ADDENDUM NO. 2

PROJECT: **BCSC - New Elementary School #12 - Maple Grove**
Tipton Lakes Blvd.
Columbus, IN 47201

ARCHITECT: **CSO Architects**
8831 Keystone Crossing
Indianapolis, IN 46240

This Addendum is incorporated with the Contract Documents for this Project and contains clarifications and revisions to the Contract Documents.

1 S203D LOW ROOF FRAMING PLAN - UNIT D

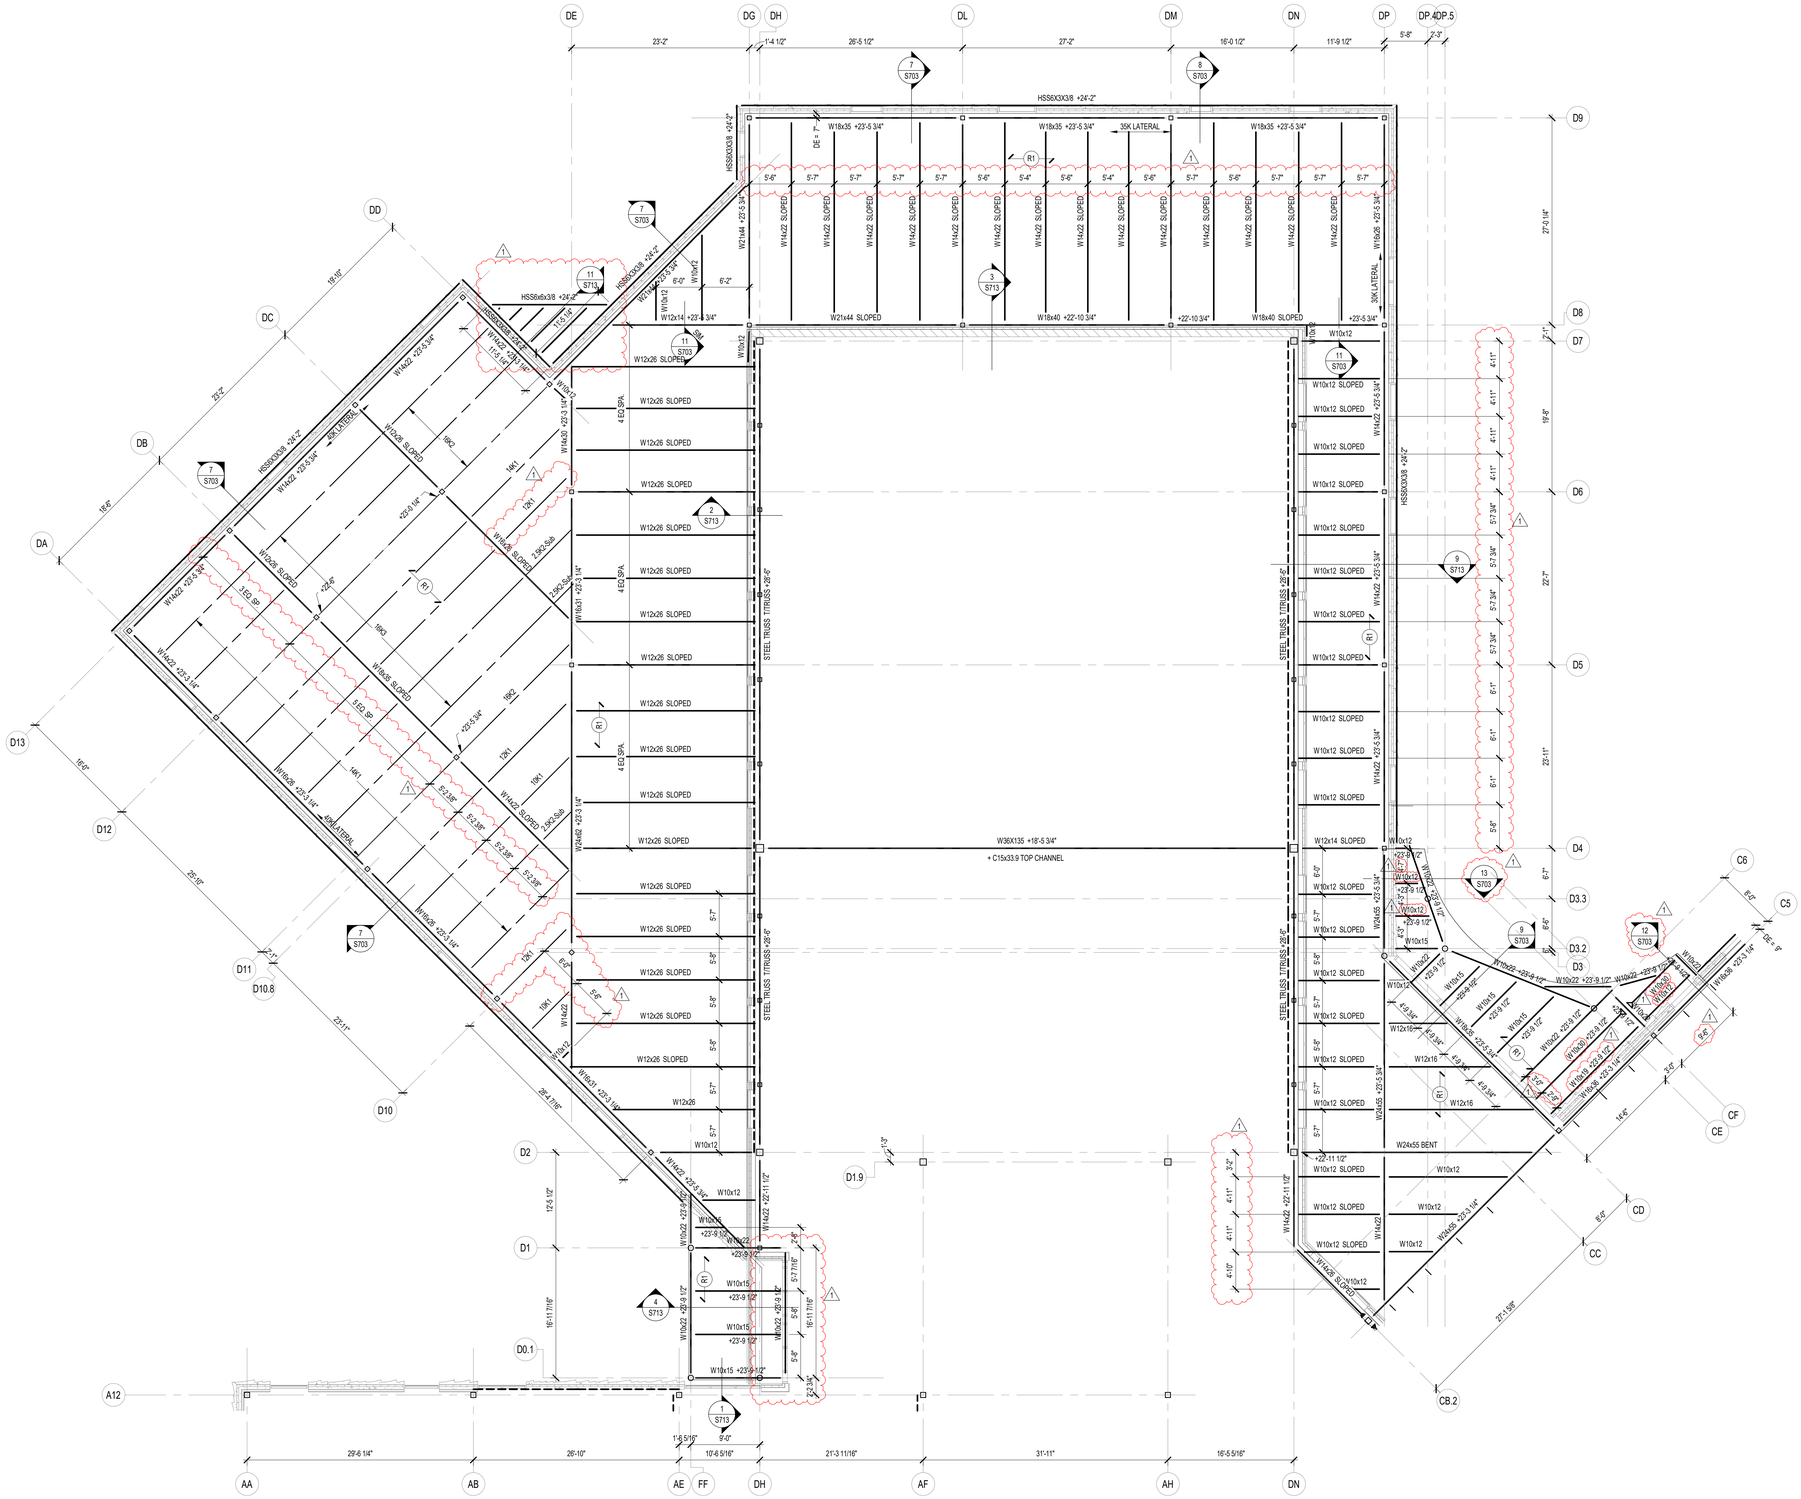
Almet, Inc.	Structural Steel - Operable Wall Support	What size is the WF beam for the operable wall support shown on detail 9/A213?	W36x135 w/ C15x33.9 top channel per S203D	CSO	6/17/25	Closed
Pepper	Gypsum Board Assemblies	1. Typical wall type is 8" above ceilings. a. Corridors have an open ceiling concept. Should these walls go 8" above the classroom ceilings? b. @ the stair walls this show drywall only 8" above ceilings. Are the stairs to be rated? c. Detail 1/A010 shows the typical wall framing and hanging 8" above deck. Can you confirm this is the intent or provide other head of wall details.	Typical walls are to go to deck unless followed by the # modifier, as noted on page A010. If the wall is followed by the # modifier, then detail 1/A010 would apply. Walls around the classrooms should go to deck unless noted otherwise. The stairs are not required to be rated. -LNM/CSO	CSO	6/17/25	Closed

GP Steel	Operable Partition Support Beam	What is the beam size required to carry the operable partition wall in the Gym, Unit D? Drawing S203D: D4 Line between DH & DN indicates "something" + a C15x33.9 channel. Drawing 9/A213 shows a Wide Flange Beam here with a channel on the top.		LHB	2025-6-18	Open
FAW	Roller Shade and Access Ladder Scope Clarification	Roller Shades are in the specialty equipment schedule but I can't find them called out in a specific bid package. Which bid package are the Roller Shades in? The Access Ladder is also on this schedule and it looks like it falls under BP-04, is that correct?	Roller shades are in BP-23 Window Treatments. Access ladder for roof hatch is in BP-04 Steel.	Pepper	2025-6-18	Closed
Lafayette Materials Management Co.	Operable Partition - Kwik Wall	Kwik-Wall is listed as an approved vender but there are two specs that do not align with their product line. 1 The specification for a steel track – Kwik-Wall has a very robust aluminum track design specifically for the electric wall 2 The specification for automatic bottom seals – Kwik-Wall offers an adjustable bottom seal that is set at install and does not need to operate. Please let me know if the owner would accept these variances before I submit a bid.		CSO	6/18/25

1 A120 COMPOSITE ROOF PLAN
SCALE: 1/16" = 1'-0"

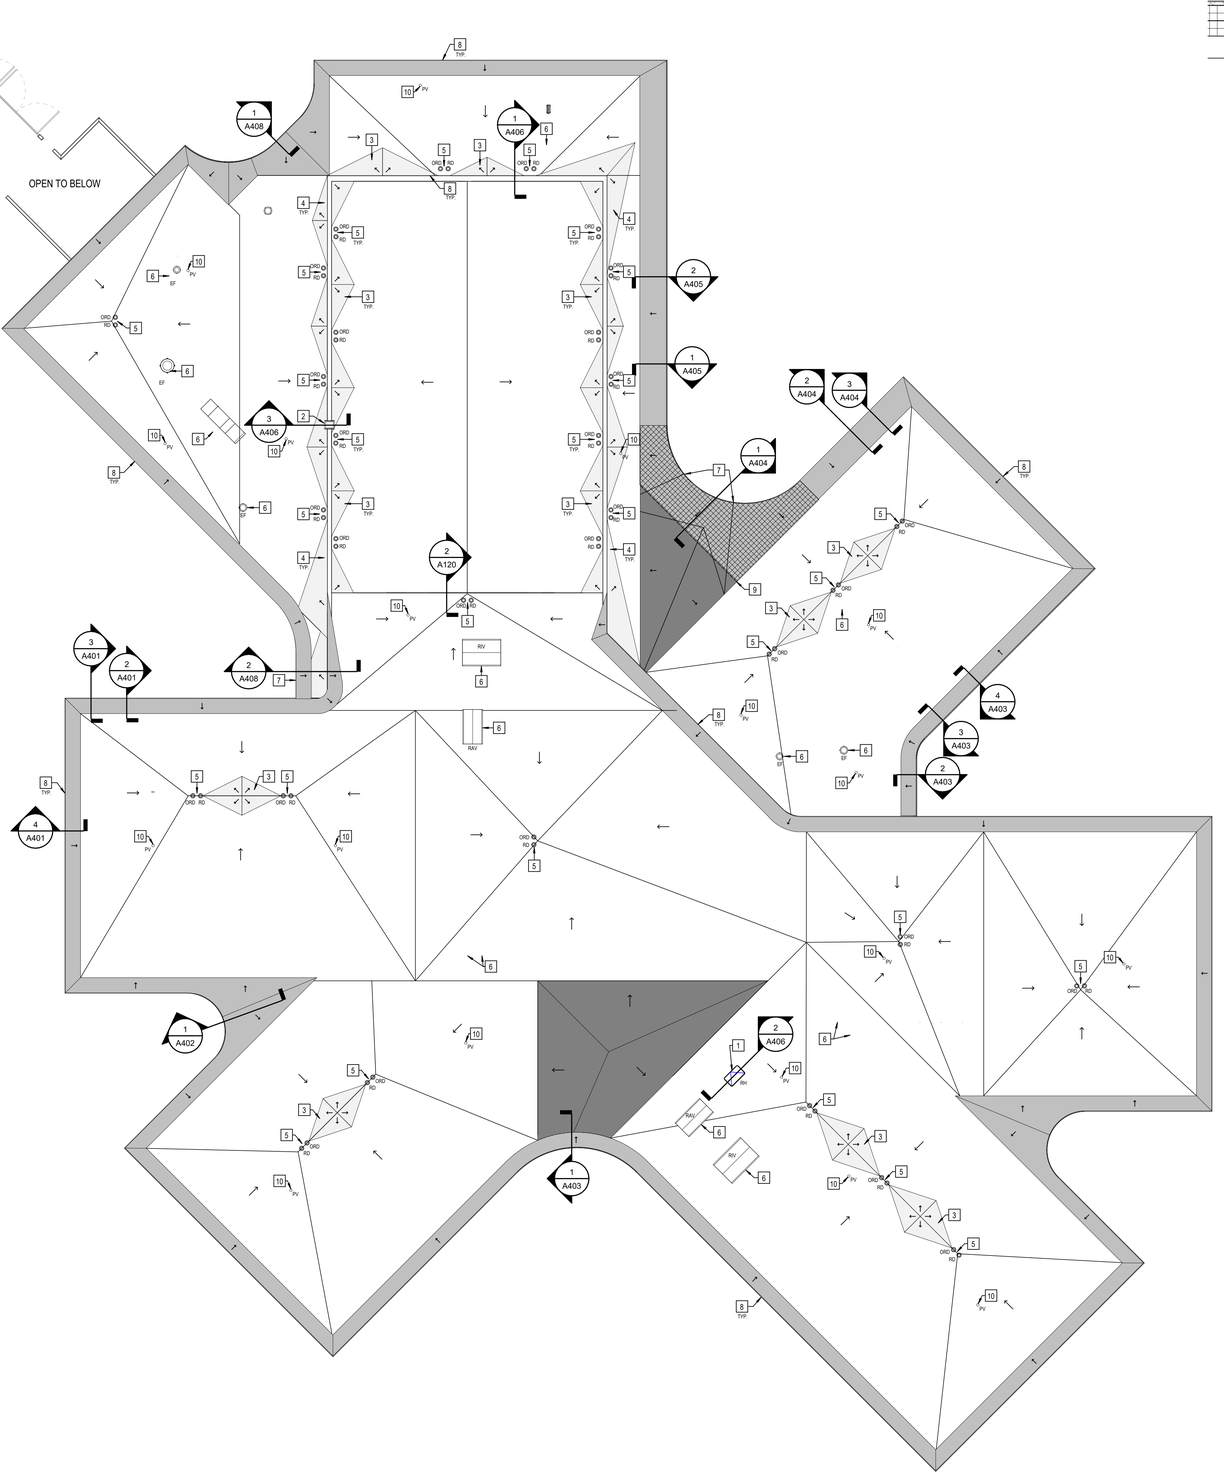
A. Revise **ROOF TYPES** as clouded on attached sheet A120.

11 A430 **ENLARGED PLAN DETAIL**
SCALE: 1 1/2" = 1'-0"

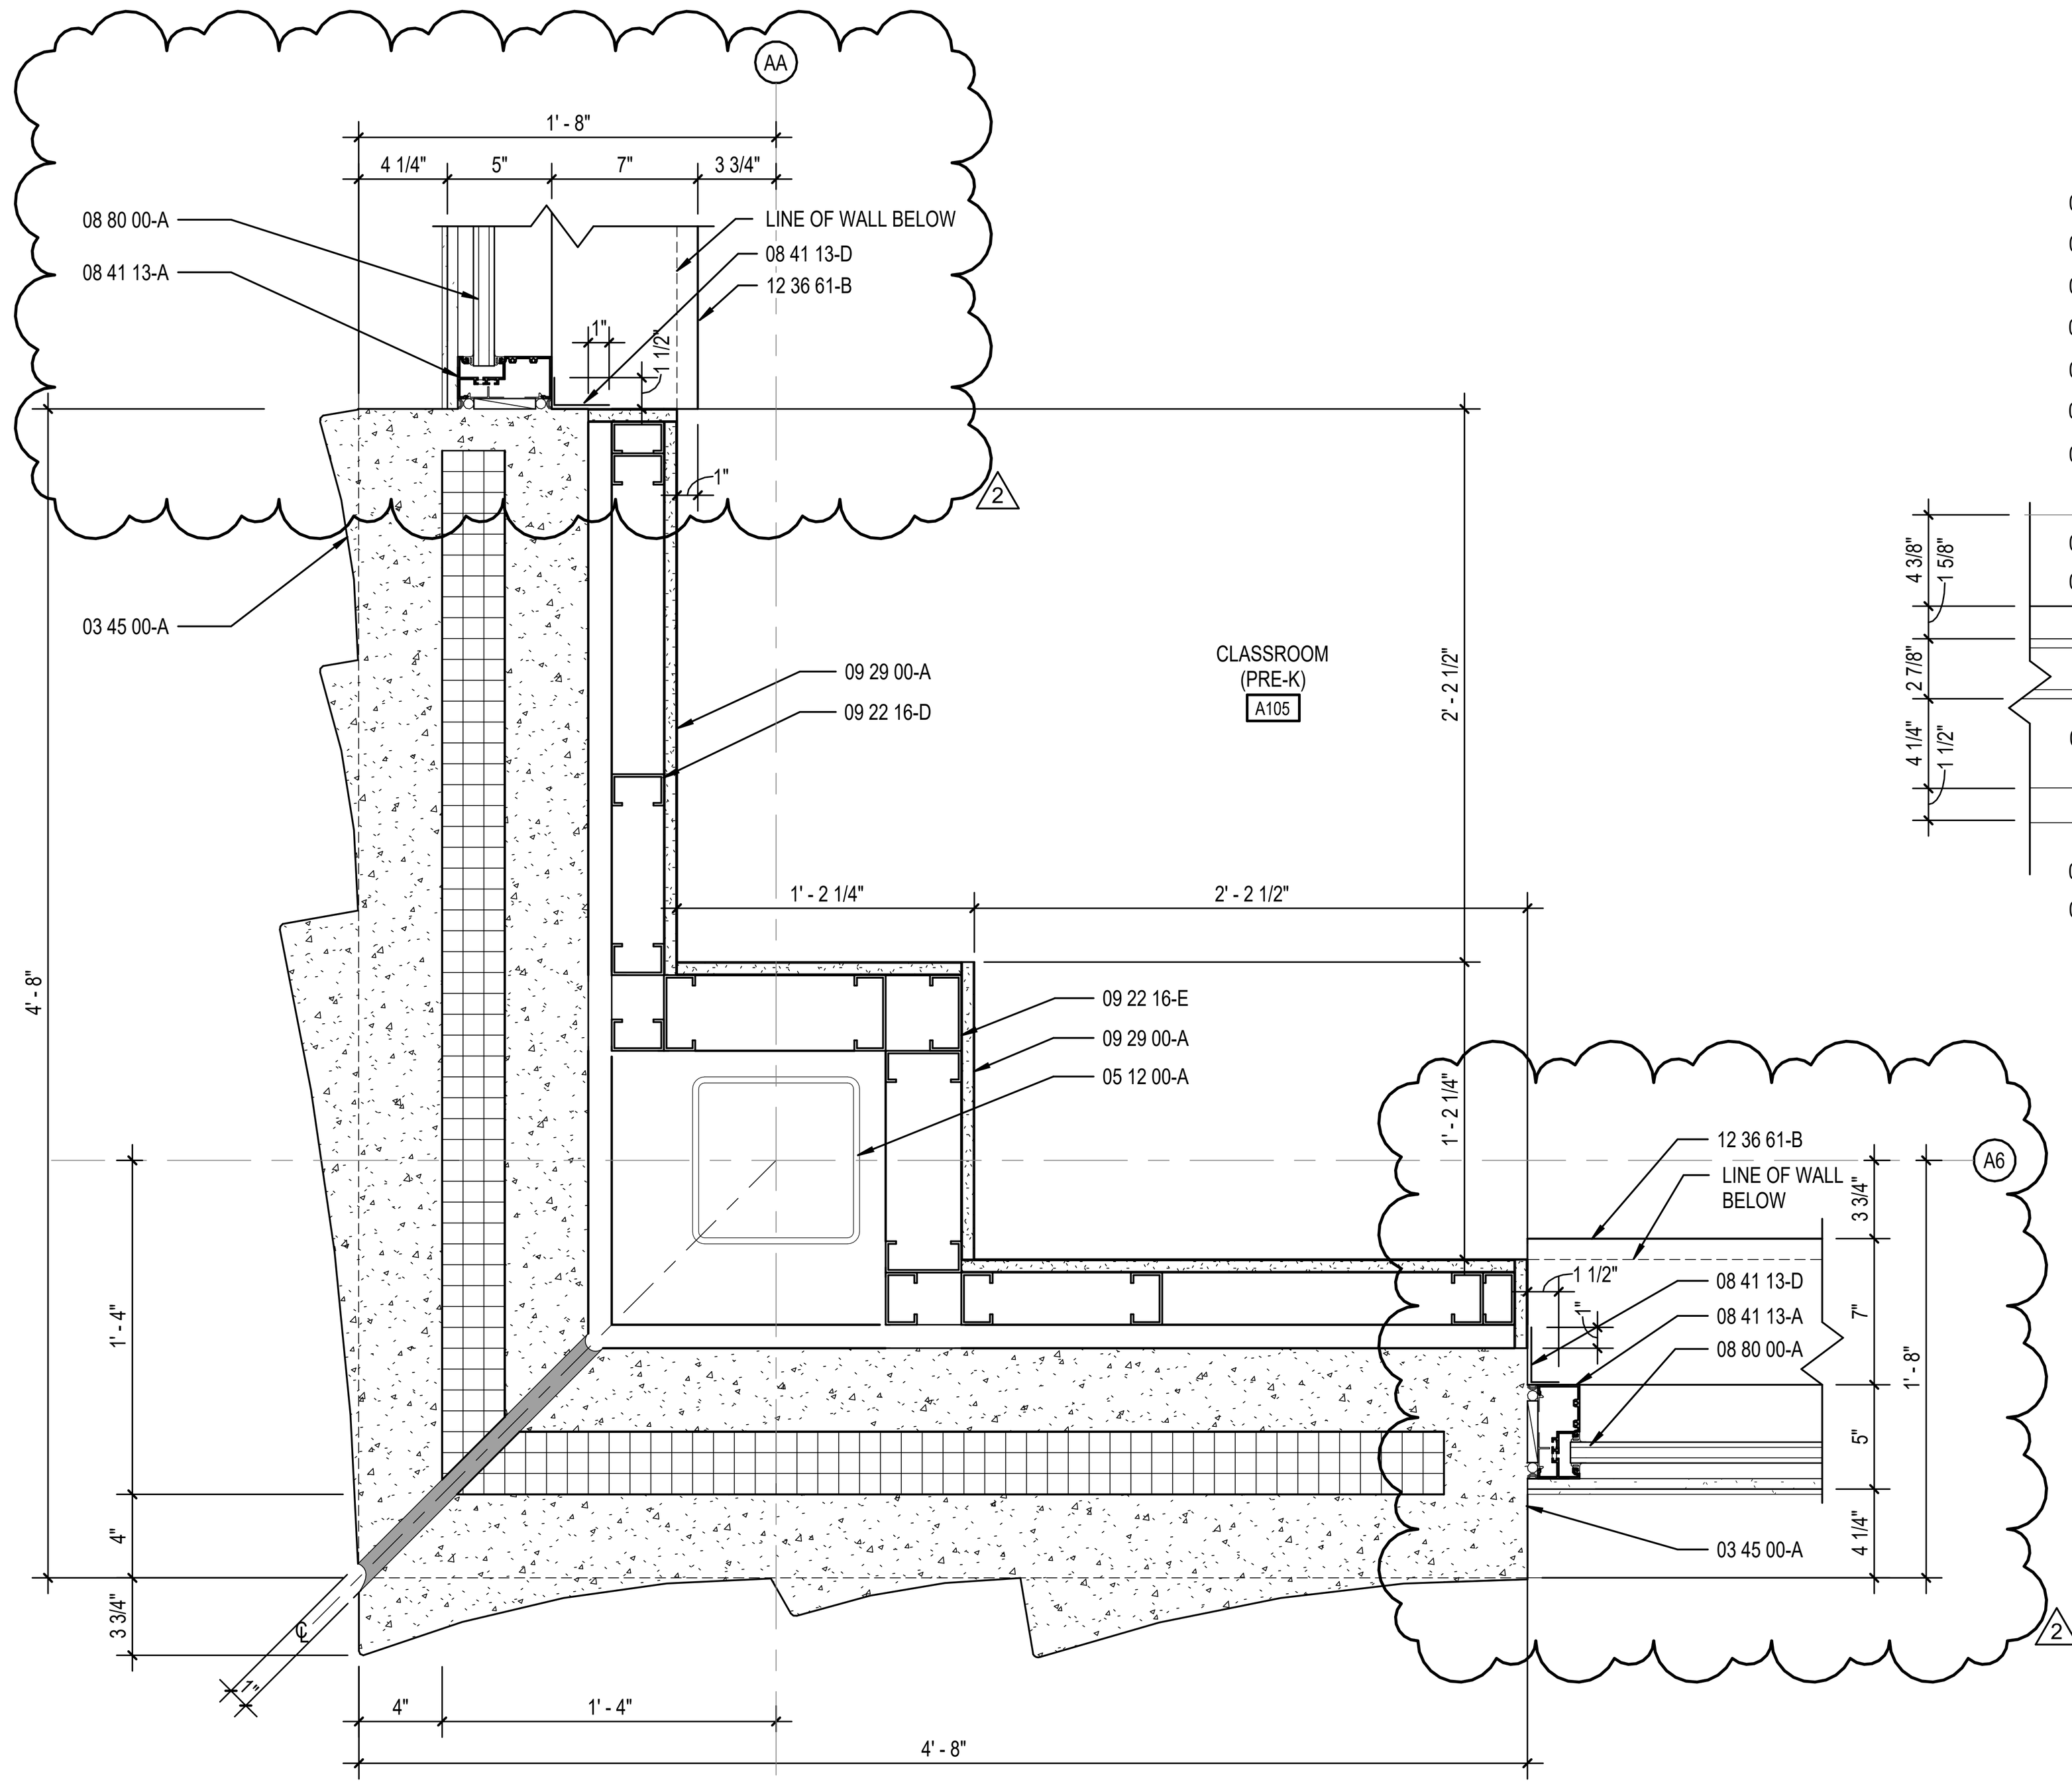
B. Detail 11/A430 ENLARGED PLAN DETAIL revise keynotes and detail as clouded on attached sheet.
